**PLANNING AND ZONING COMMISSION  
CITY OF BETTENDORF  
SEPTEMBER 16, 2020 AT 5:30 PM  
CITY HALL COUNCIL CHAMBERS  
1609 STATE STREET**

**MINUTES  
PLANNING AND ZONING COMMISSION  
AUGUST 19, 2020  
5:30 P.M.**

GRADING & OVERALL SITE PLAN

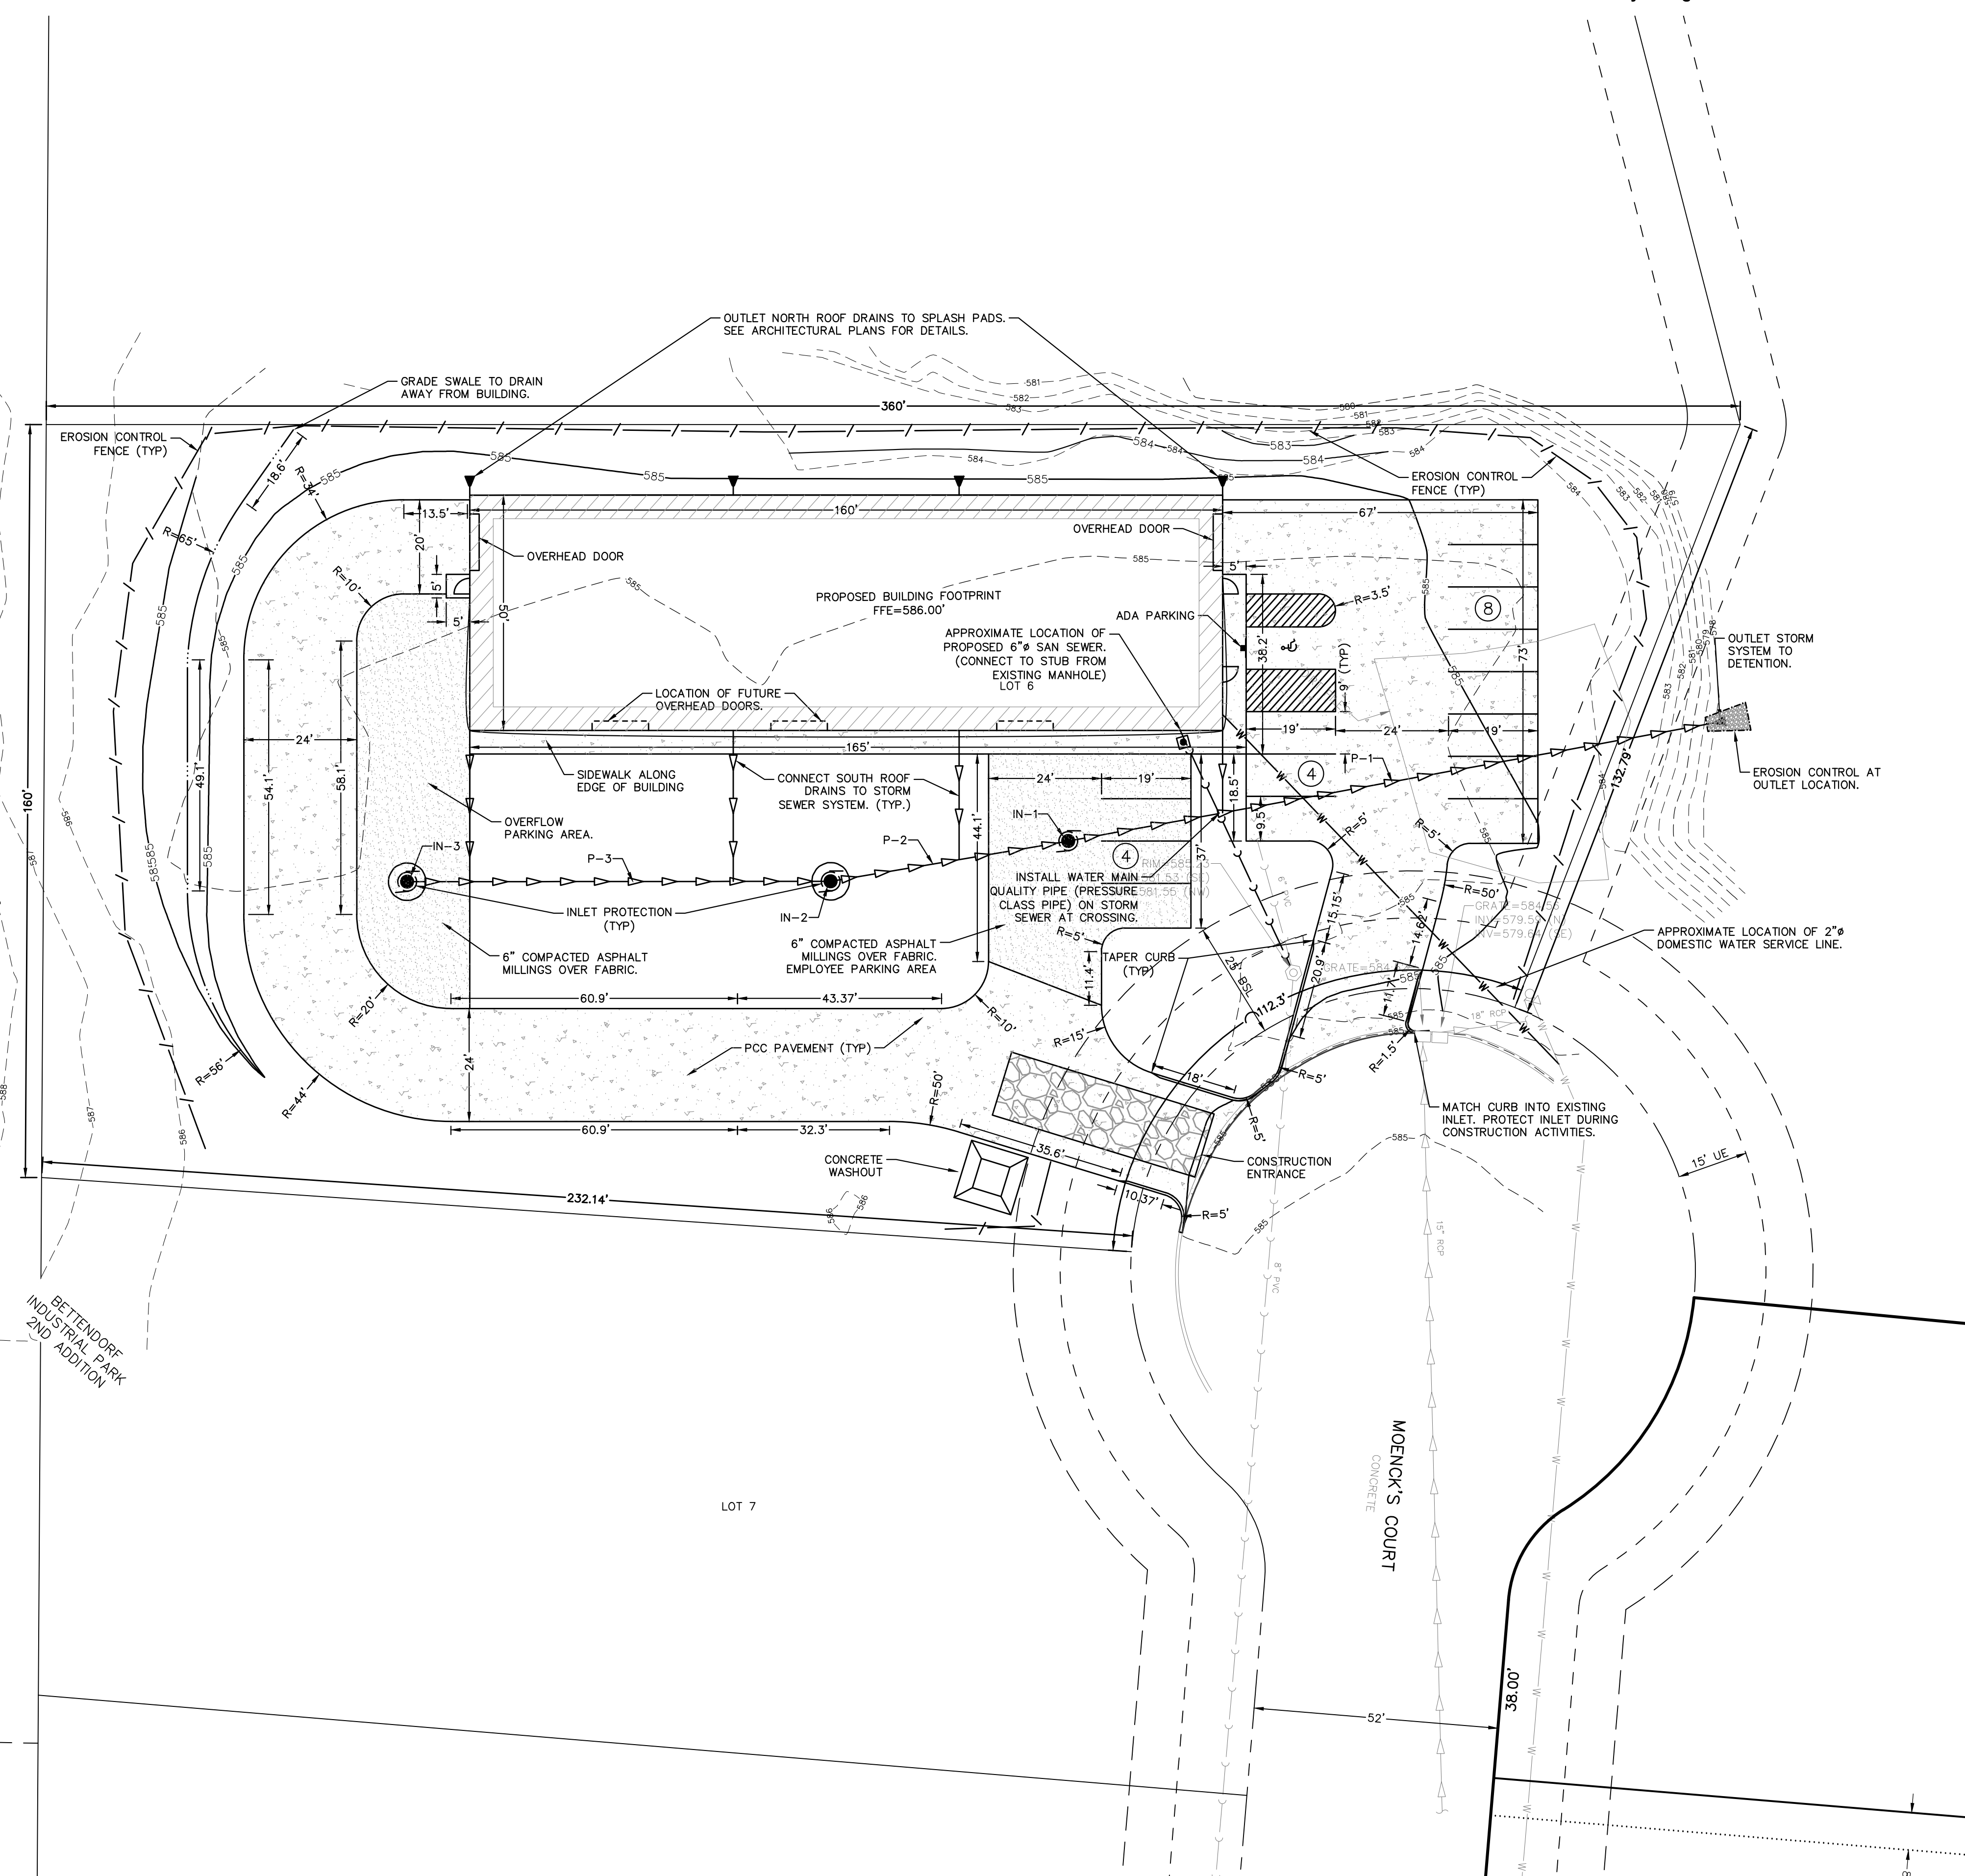
Staff recommends the Planning and Zoning Commission support approval of the site development plan subject to the following conditions:

1. Approval of the site development plan does not waive any applicable city, state, or federal provisions as required by law.
2. All storm water purity calculations must be approved by the City Engineer prior to City Council approval of the site development plan.
3. Hydrant must be located near the site per Bettendorf Fire Department. Hydrant and distance to building must be shown on the site development plan.
4. Wetlands in Outlot A will not be impacted by any development on Lot 6 beyond what is permitted by federal, state and local regulations.

**SITE PLAN**  
**RICHARD**  
**28th ST. PROPERTY**  
**TO THE CITY OF BETTENDORF, IA**

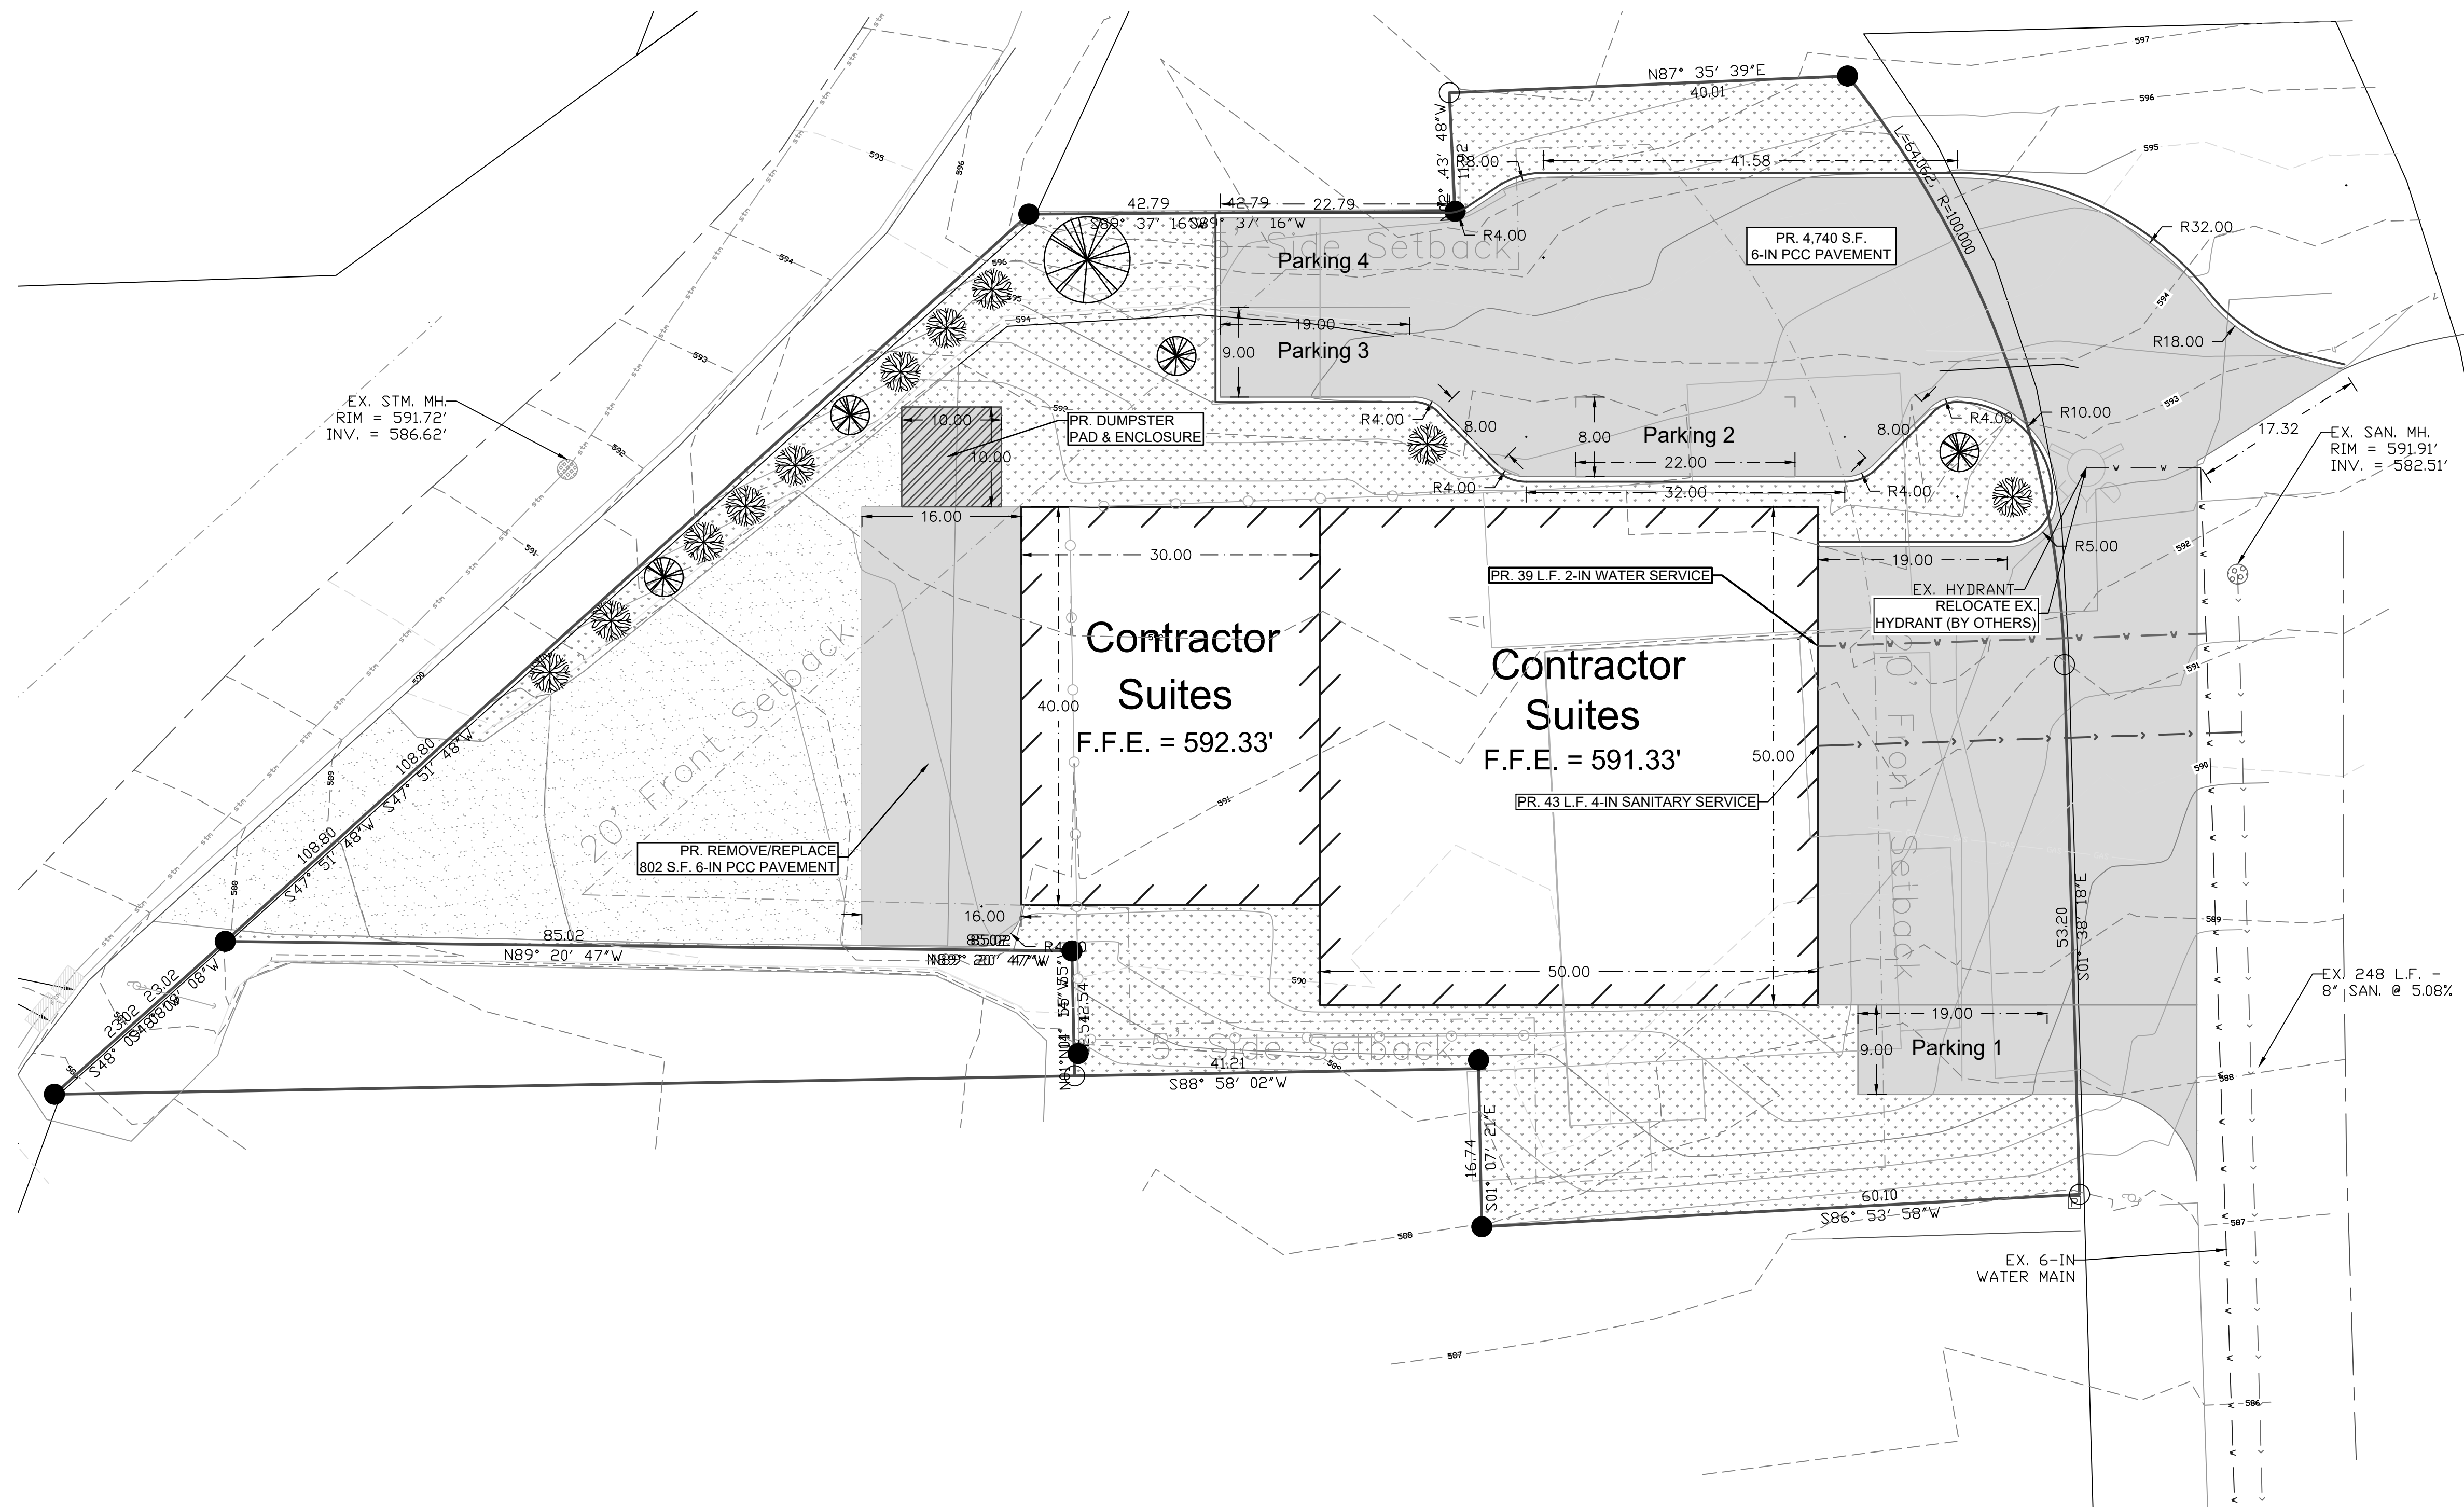
Storm water detention was not required for this site when the initial building was built. The City Engineer has determined all requirements for offsite flow and storage have been met.

Staff recommends approval of the site development plan subject to the following conditions:
